Planning and Zoning Commission October 4, 2022 In Person at Grimes Community Complex, 410 SE Main Street, Room 202

TO: Planning and Zoning Commission
FROM: Molly Mannel, Assistant Planner
DATE: October 4, 2022
RE: Brookside Village Plat 1 – Preliminary Plat

RE: Brookside Village Plat 1

BROOKSIDE VILLAGE PLAT 1

1	COVER SHEET
2	DETAILS
3-4	DIMENSION AND CONCEPT PLAN
5-6	UTILITY AND GRADING PLAN

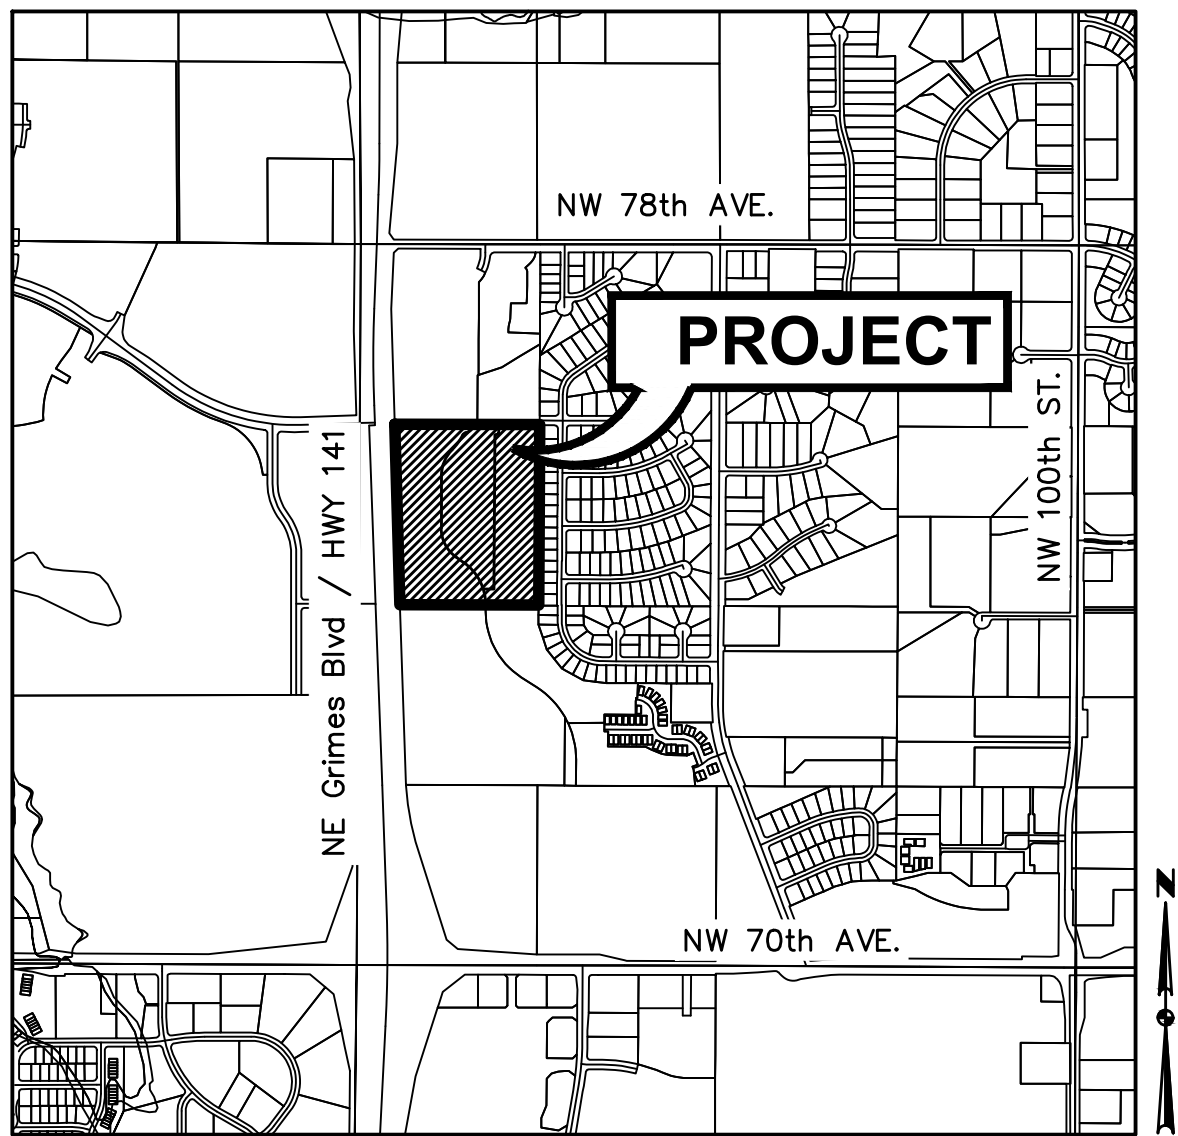
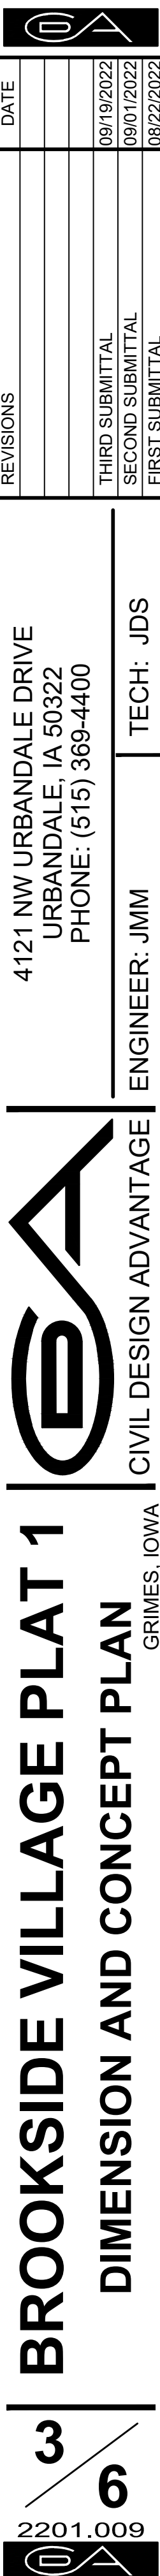
1. Staff finds the name Brookside Village could confuse residents and first responders due to the site not being located near Brookside Drive. Please revise.

2. Please state under ZONING the zoning change from A-1, and the development agreements with BK/PG. ~~Please remove the existing and proposed—as the A-1 zoning is no longer existing. Please just state that the site was previously zoned under A-1 and list the new zoning like you've done.~~

3. Please revise the P.U.D. BULK REGULATIONS to just BULK REGULATIONS—or separate the R-3 Med Density Residential under a different heading. The R-3 Med is not within the P.U.D.

4. Please show the lot lines/separation between Lot 7 and Lot 8.
5. Please remove the Highway 141 Mixed Use Corridor requirements under Bulk Regulations.

6. Please update with the following numbers for the **R-3 Medium Density Residential District**, as per the development agreement:
 - a. Lot Minimum—No minimum lot dimensions apply. Postage Stamp lot development is permitted.

- b. Side Yard Setback—please change 1 story to 10' each side.
 - c. Building Separation—20'
 - d. Max Height—35'
 - e. Open Space—please state the 40% minim open space requirement.

- f. Parking—2 car attached garage/unit—and 1 guest space/ 5 units.

8. Please update with the following numbers for the **C-2 General Highway Service and Commercial District (PUD)**, as per the development agreement:

DIMENSION AND CONCEPT PLAN

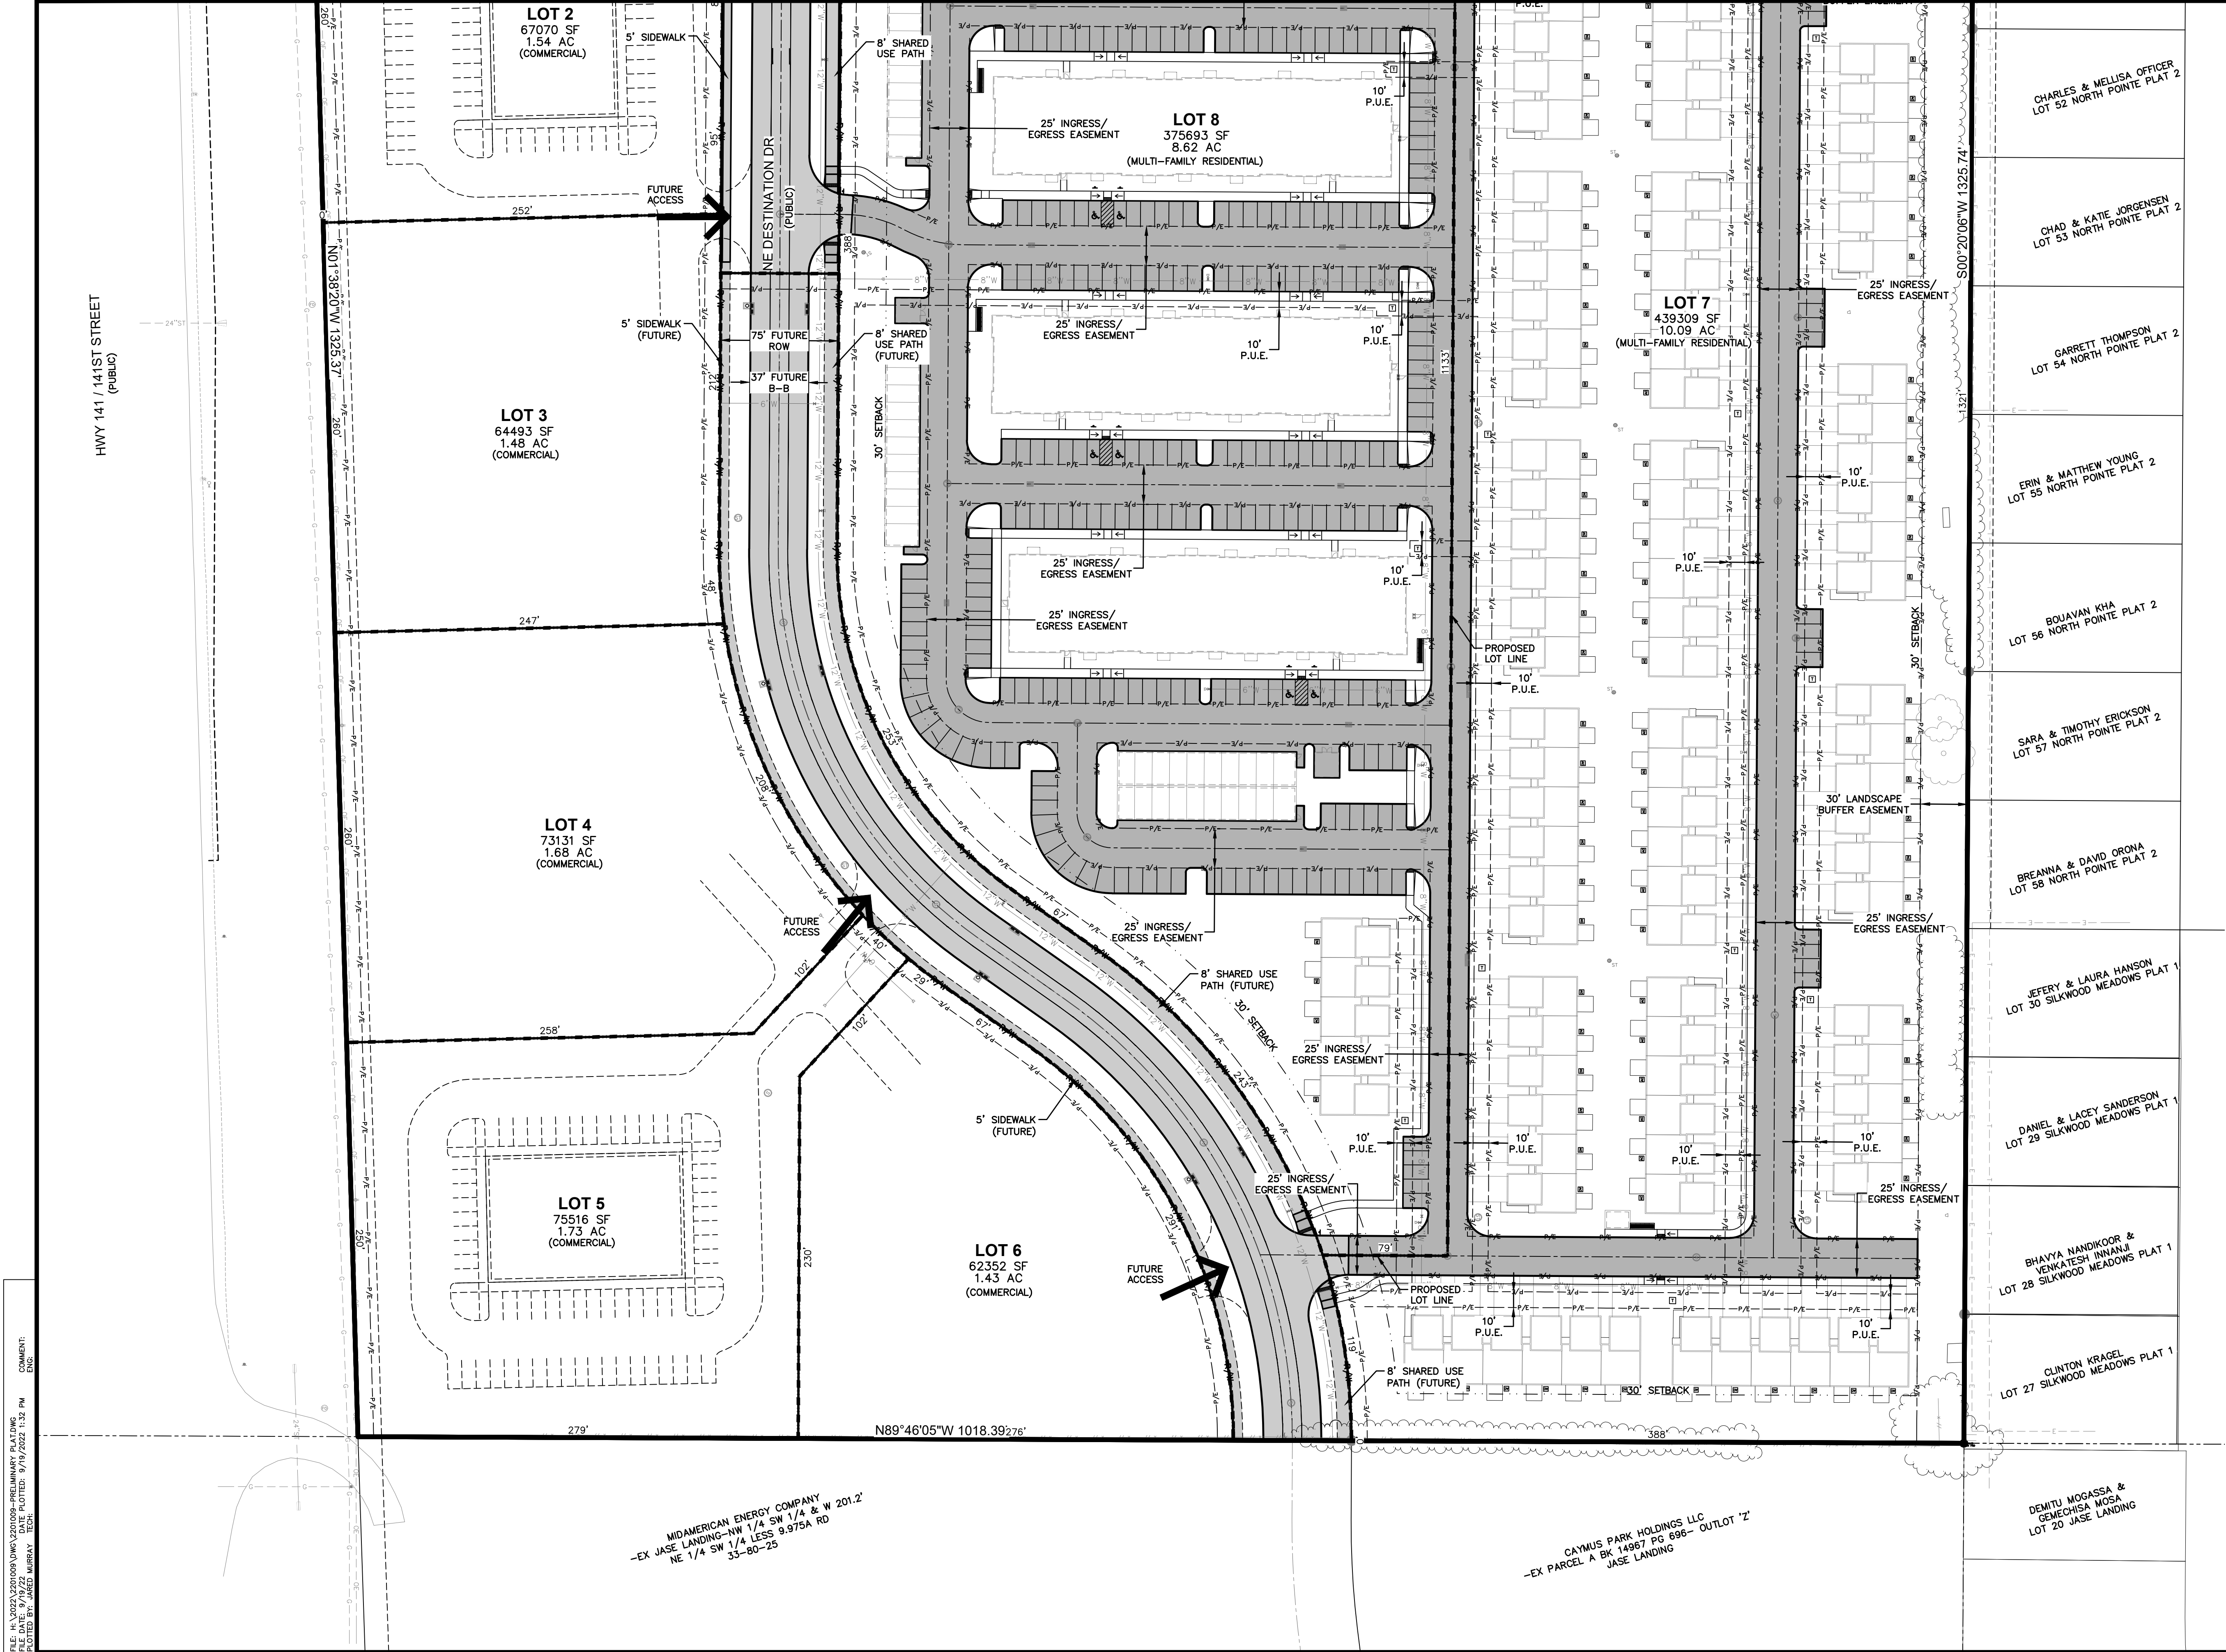
1. ~~Please remove the access between Lots 3 and 4.~~

UTILITY AND GRADING PLAN

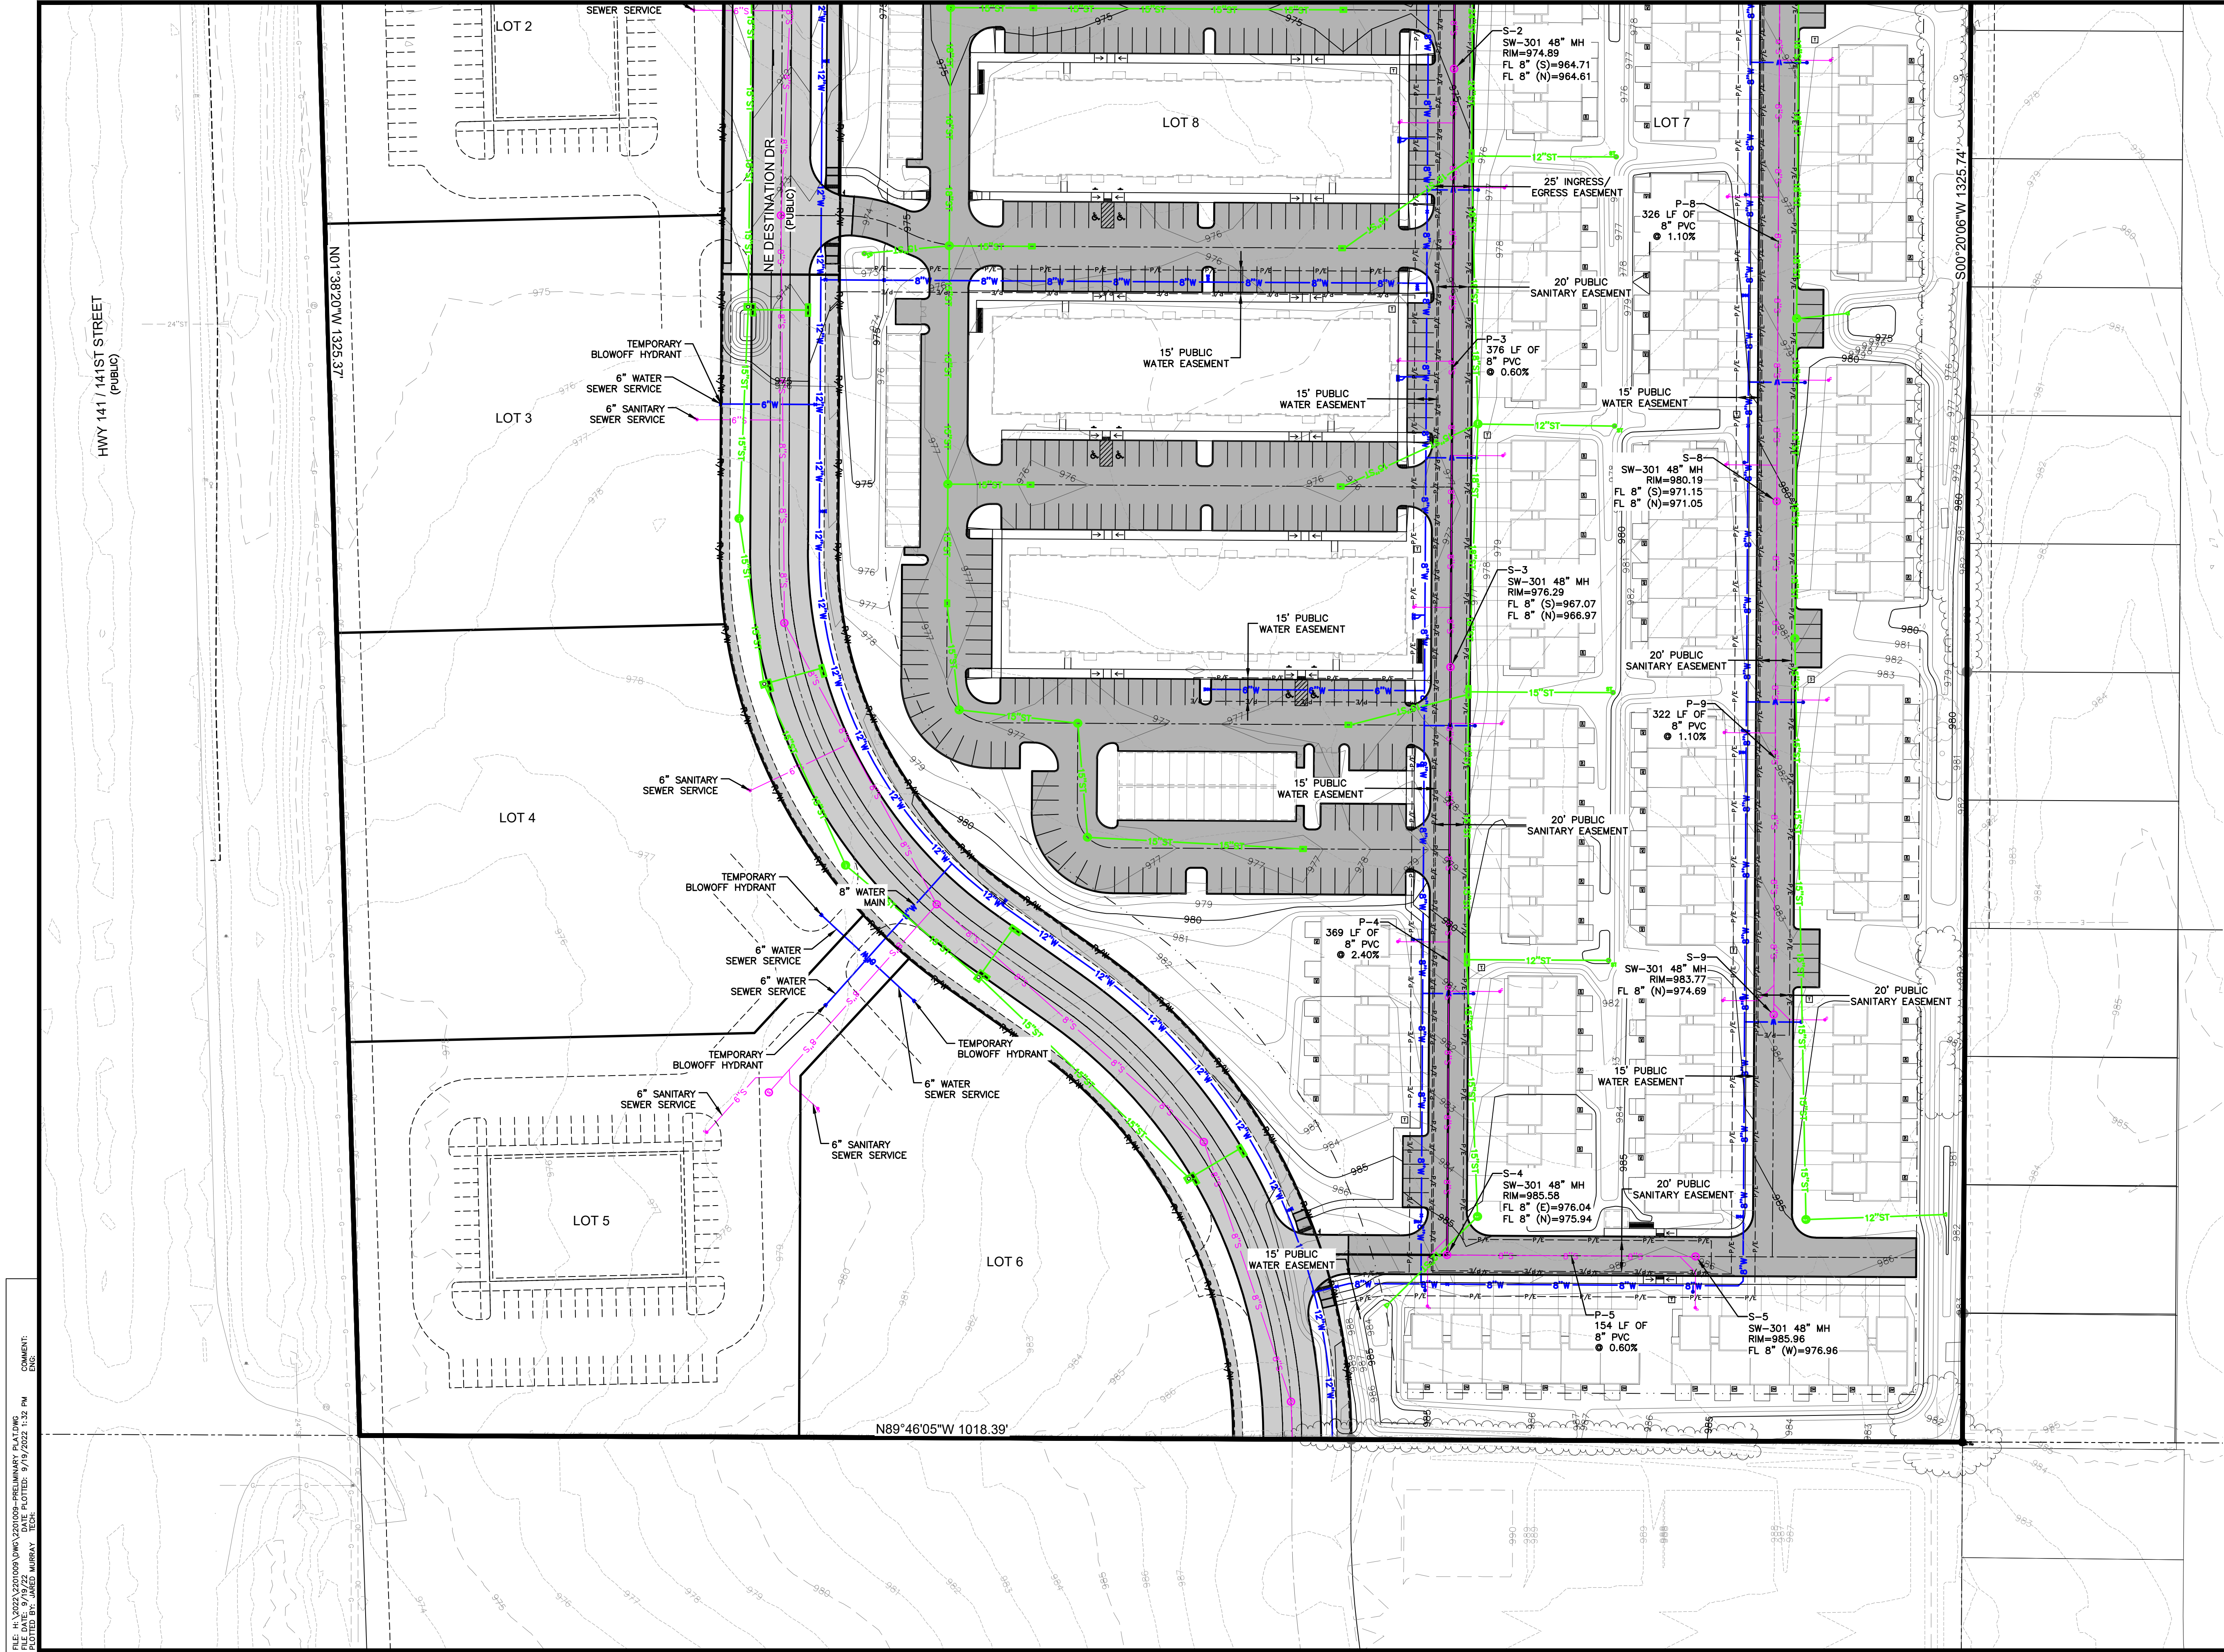
1. ~~Please remove the access between Lots 3 and 4.~~
